Access Compliance Report Public Rights-of-Way (Curb Ramps)

Intersection ID: 3603 Main Street: MOUNTAIN PARK DR Cross Street: MT ISLE HARBOR DR Location: NW **Overall Compliance: No Severity Score:** ADA ID: 4111AF287965 Ramp Type: Perp Initial Pass/Fail: Fail 12.5

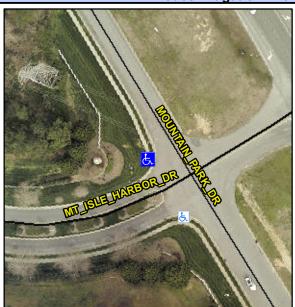
MT ISLE HARBOR DR Street 1 Name Stop Condition-Street 2 StopSign N/A Street 2 Name Stop Condition-Street 1 N/A Possible Solutions: Remove & Replace Entire Ramp. Surveyor Notes: N/A PROW/ADA: Not Found, R304.2.2

Total Cost: 1850.00 Compliance Description Data Compliance Description Data No N/A Ramp Length (in) 47.5 Ramp Slope (%) 8.7 Yes Ramp XSlope (%) Yes Ramp Width (in) 48.0 1.8 N/A N/A Flare Type LT N/A Flare Type RT N/A N/A N/A N/A Flare Slope RT (%) N/A Flare Slope LT (%) N/A Flare Traversable LT? N/A N/A Flare Traversable RT? N/A N/A N/A N/A **DWS Provided?** N/A Landing Length (in) N/A Landing Width (in) N/A N/A **DWS Contrast?** N/A N/A N/A N/A Landing Slope (%) DWS Length (in) N/A N/A Landing X Slope (%) N/A N/A DWS Full Width? N/A N/A Landing Curb? (Y/N) N/A N/A DWS Offset (in) N/A N/A N/A Shared Landing? N/A **Gutter Ponding?** N/A N/A Gutter Slope (%) N/A N/A Gutter Lip Ht (in) N/A N/A Gutter X Slope (%) N/A N/A Painted X Walk1? No N/A Painted X Walk2? N/A X Walk 1 Direction To S X Walk 2 Direction N/A N/A N/A X Walk 2 Width (in) X Walk 1 Width (in) N/A X Walk 1 Slope (%) 0.1 X Walk 2 Slope (%) N/A X Walk 1 X Slope (%) 3.5 X Walk 2 X Slope (%) N/A N/A N/A N/A Ramp inside XWalk2? Ramp inside XWalk1? N/A Road Slope (%) N/A N/A Clear Space? N/A N/A Road X Slope (%) N/A Clear Space to XWalk (in) N/A N/A N/A Any Obstructions? N/A Storm Grate/Utility Hazard? N/A **Obstruction Type** Storm Grate/Utility Type N/A N/A Yes Surface Condition? (G/P) Good
